**CITY OF MERIDIAN
FINDINGS OF FACT, CONCLUSIONS OF LAW
AND DECISION & ORDER**

In the Matter of the Request for Annexation and Preliminary Plat for Poiema Subdivision, by Dave Evans Construction.

Case No(s). H-2020-0035

SUBJECT: H-2020-0035
Poiema Subdivision

D. REVISED Plat (dated: 06/15/2020 7/30/2020)

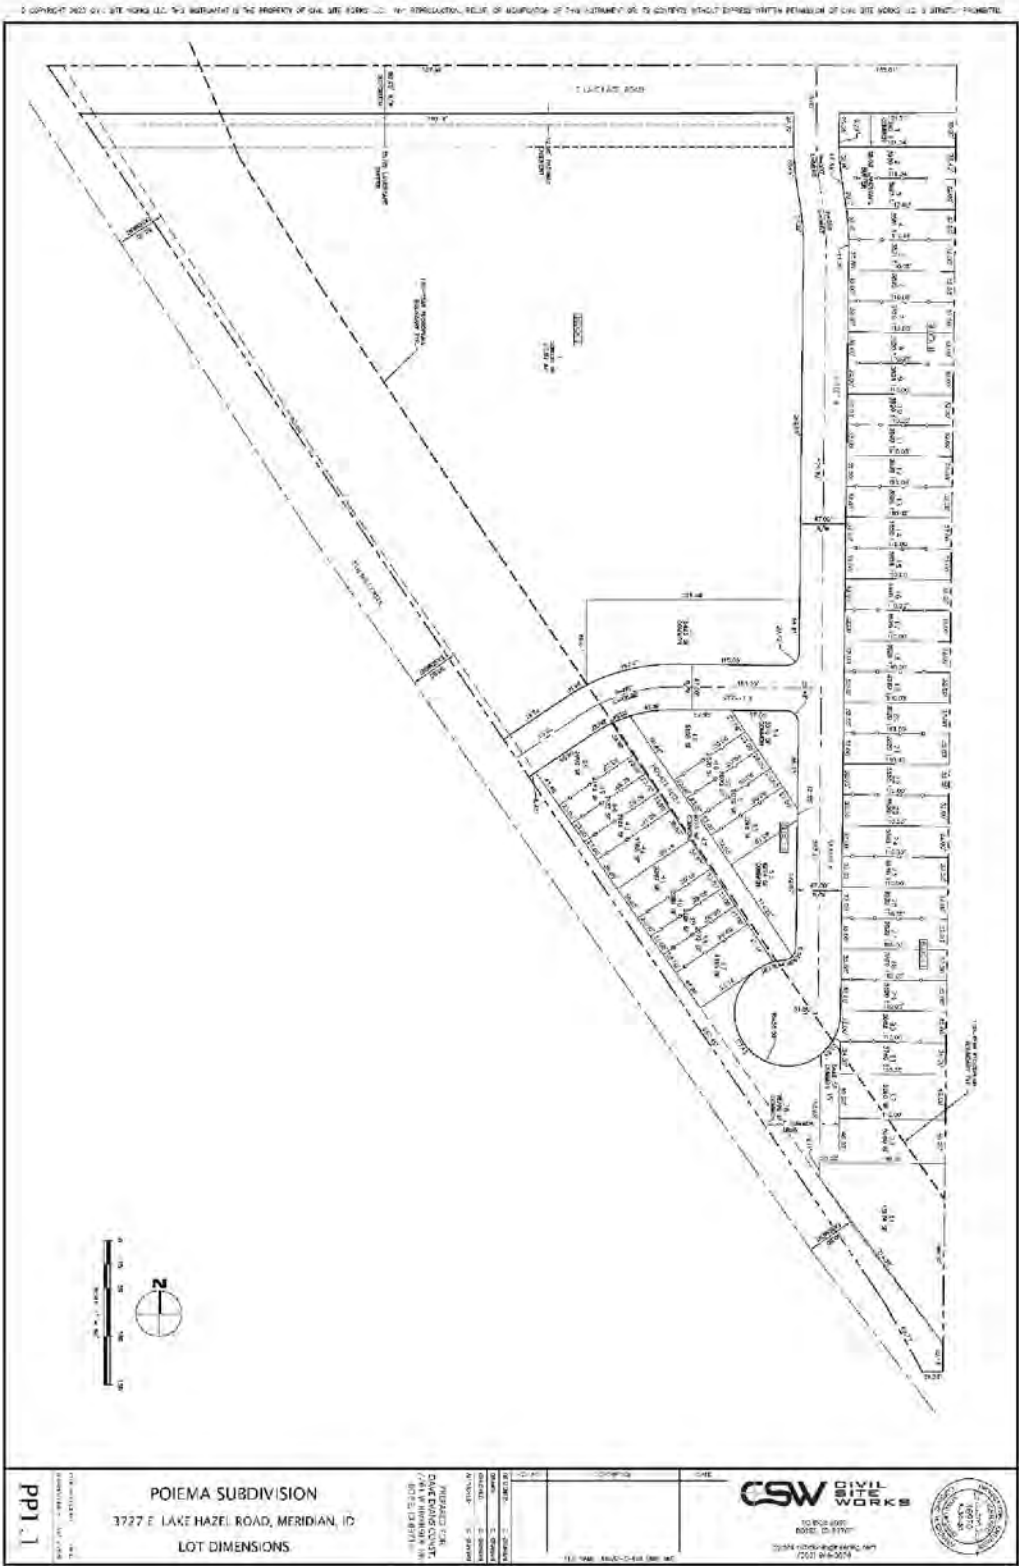
The proposed lots along the eastern boundary and the public streets appear to meet all UDC dimensional standards per the submitted preliminary plat. This includes property sizes, required street frontages, and road widths. The revised preliminary plat submitted by the Applicant shows townhomes off of a private alley. It is the understanding of Staff that ACHD has not yet given comments on the precise location of this alley but are generally supportive of it. Per the revised plat, all lots appear to meet UDC dimensional standards for the R-15 zoning district and attached single-family unit type.

The revised preliminary plat shows a private alley that connects to the future western stub street and the proposed cul-de-sac. As stated above, Staff is unaware of ACHD's formal approval of this location but has also not been given notice of its denial. The Applicant should continue working with ACHD to ensure the location of the alley meets all ACHD requirements. The proposed alleyway is shown as 20 feet wide which meets UDC and Fire requirements; the alleyway will be deemed as a no parking zone for its entirety. Staff supports this alleyway and the alley loaded type of home for this development.

3. ~~Ten (10) days prior to the City Council hearing, the~~ The revised preliminary plat included in Section VII.CD, dated 04/15/2020 July 30, 2020, shall be revised as follows is approved as submitted.

- ~~a. Add a note prohibiting direct lot access via E. Lake Hazel Road.~~
 - ~~b. Show Lot 34, Block 1, to include that common open space area outside of its fence, adding it to this lot and removing it from any common lot to eliminate a potential safety and crime hazard.~~

- d. ~~Provide traffic calming at the internal intersection to break up the block length of the proposed "Street A". Work with ACHD on appropriate measure to ensure pedestrian safety at this intersection.~~

E. Open Space Exhibit (dated: 06/15/2020-August, 2020)

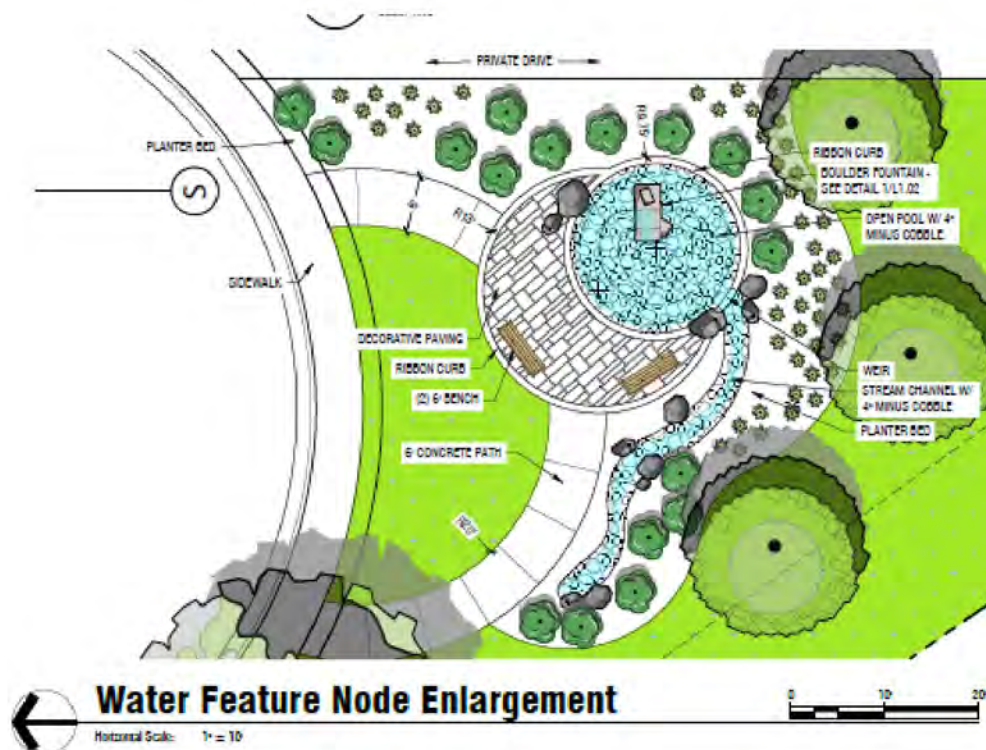
On the revised open space exhibit (Section VII.E) there is an area less than 5,000 square feet located between the alley and the local street. UDC requirements state that in order for this area to be qualifying it must be at least 50' by 100' in dimension. Staff uses their discretion when the open space area can meet the 5,000 square foot area requirement but may not meet the precise dimensions above. In this case, this area meets neither of these benchmarks and Staff believes it is not qualifying open space. With this area removed from the open space calculations, Staff has calculated that the qualified open space for the site is approximately 0.64 acres, or approximately 10.57%. The proposed open space still meets UDC minimum requirements and Staff finds that the open space with the water feature and the large open space lot in the center of the development are sufficient for the number of homes proposed in this development.

The required landscape buffer along E. Lake Hazel should be shown on the open space exhibit even though it is not qualifying open space. As stated above, Staff recommends these improvements be completed with development of the residential portion of the site. The open space exhibit should be revised to show this area to give a more complete picture of all open space on the site in accordance with UDC 11-3G-3.

- 5. ~~Ten (10) days prior to the City Council hearing, the open space exhibit included in Section VII.E shall be revised to show the required 35-foot landscape buffer along E. Lake Hazel and show this area in the calculations table.~~

F. Landscape Plan (date: 4/3/2020-8/03/2020)

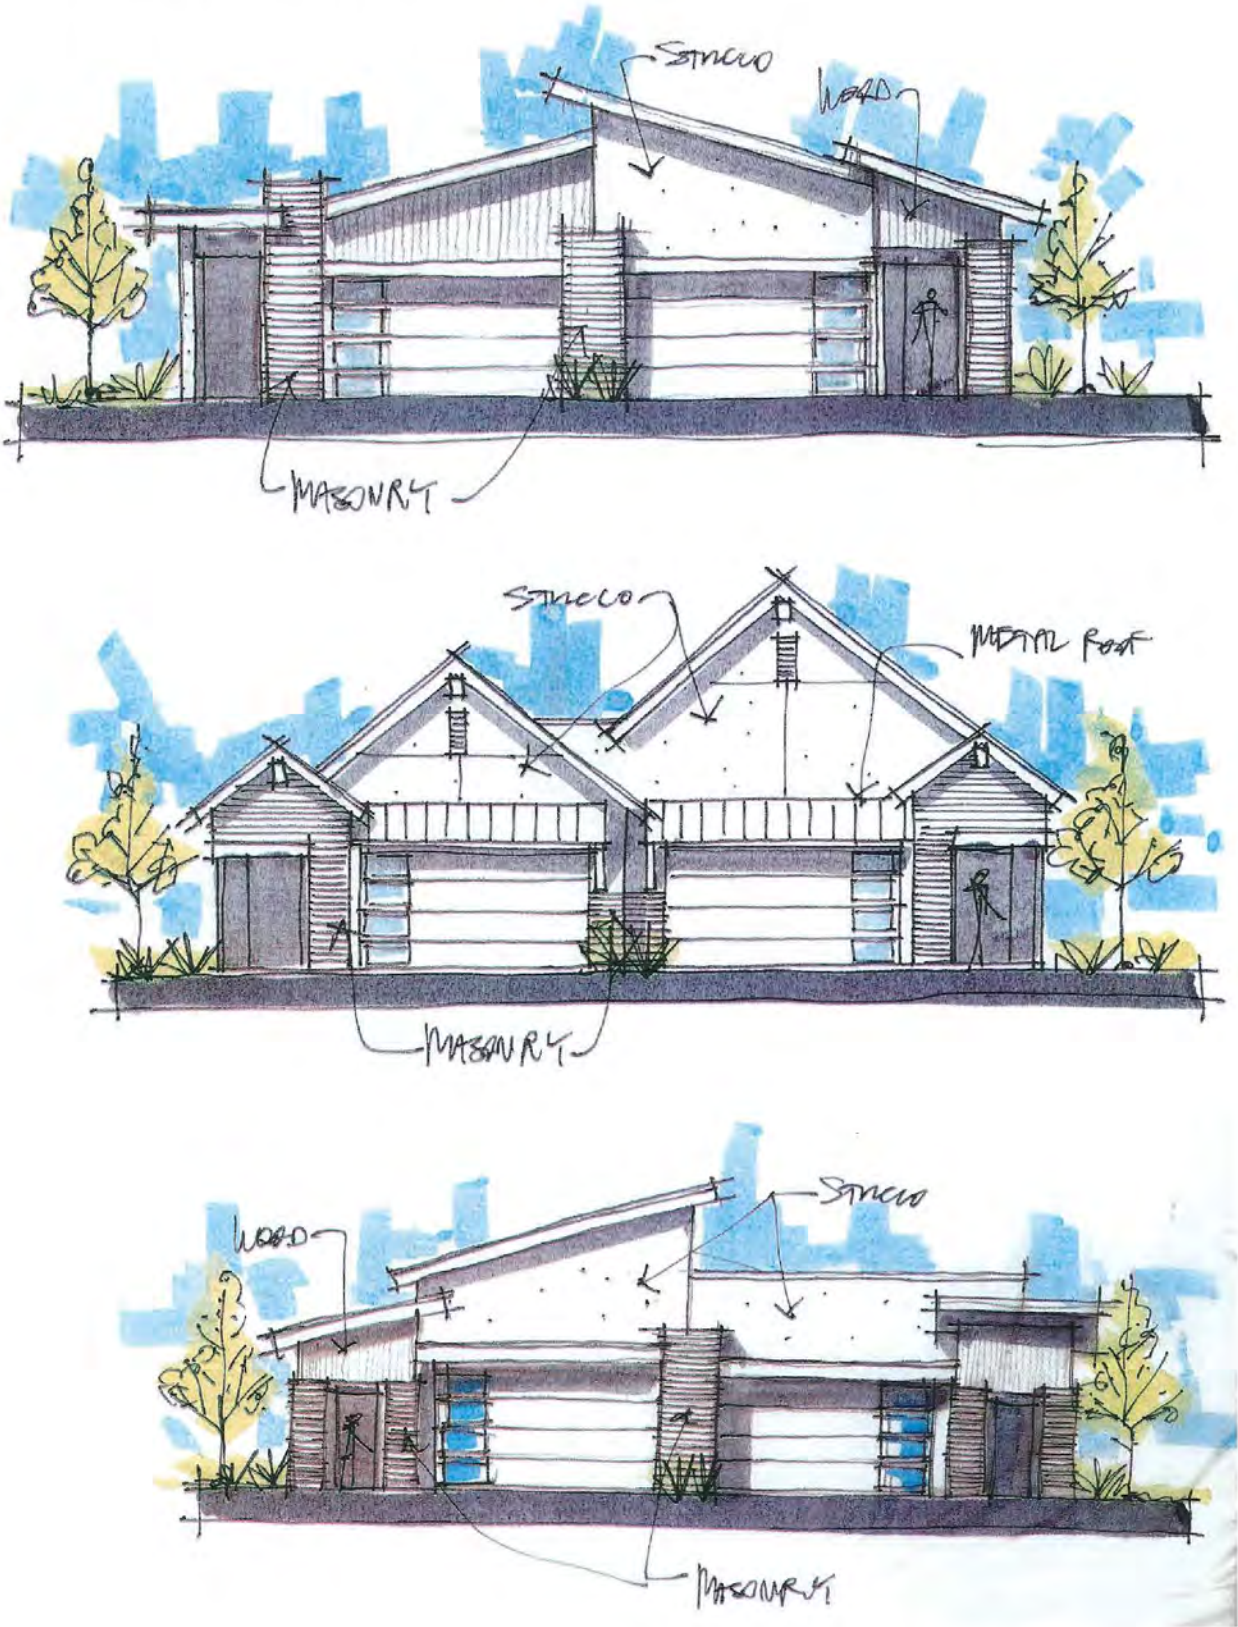
Common open space is required to be landscaped in accord with the standards listed in UDC 11-3G-3E. *The total square footage of common open space are included in the Landscape Calculations/Requirements table along with the required number of trees to demonstrate compliance with UDC standards but has not been updated to depict the new layout. Staff recommends the Applicant submit a revised landscape plan at least ten (10) days prior to the City Council hearing to show the new layout and match the other revised plans.*

Also shown on the landscape plan is an area directly to the west of Lot 34, Block 1 that is within the Ten Mile Creek easement. This area of the development is not open on both ends and does not offer easy visibility. Staff is concerned with potential safety and crime issues in this small area. UDC 11-3G-3D.3 states that "common open space shall be located in areas of high visibility to avoid hidden areas and corners..." This area is not qualifying open space because it is not open on both ends but it is still common open space and must adhere to these standards. Therefore, Staff is recommending a condition of approval that this area be part of Lot 34, Block 1 to alleviate this potential safety issue. In addition, the Applicant is proposing an additional 8 trees in order to mitigate trees that are being lost with the development of this site. This note is stated on the submitted landscape plan.

All fencing is required to comply with the standards listed in UDC 11-3A-7. Fencing is shown on the landscape plan but is not made clear as to what type of fencing it is. Fencing shown next to any open space shall be open-vision or semi-private fencing per UDC requirements.

- 4. ~~Ten (10) days prior to the City Council hearing, the~~ The revised landscape plan included in Section VII.F, dated ~~05/04/2020~~ August 3, 2020, ~~shall be revised as follows is approved.~~

- a. ~~Label and depict the type of fencing proposed throughout the development; all fencing shall comply with the standards listed in UDC 11-3A-7.~~
 - b. ~~Revise the landscape plan to show the new layout and townhome units; any changes in landscape calculations shall also be reflected in the calculations table.~~

- c. ~~Correct the landscape buffer along E. Lake Hazel to show the required 35-foot buffer width in accordance with the dimensional standards for R-15 zoning district, UDC 11-2A-7.~~
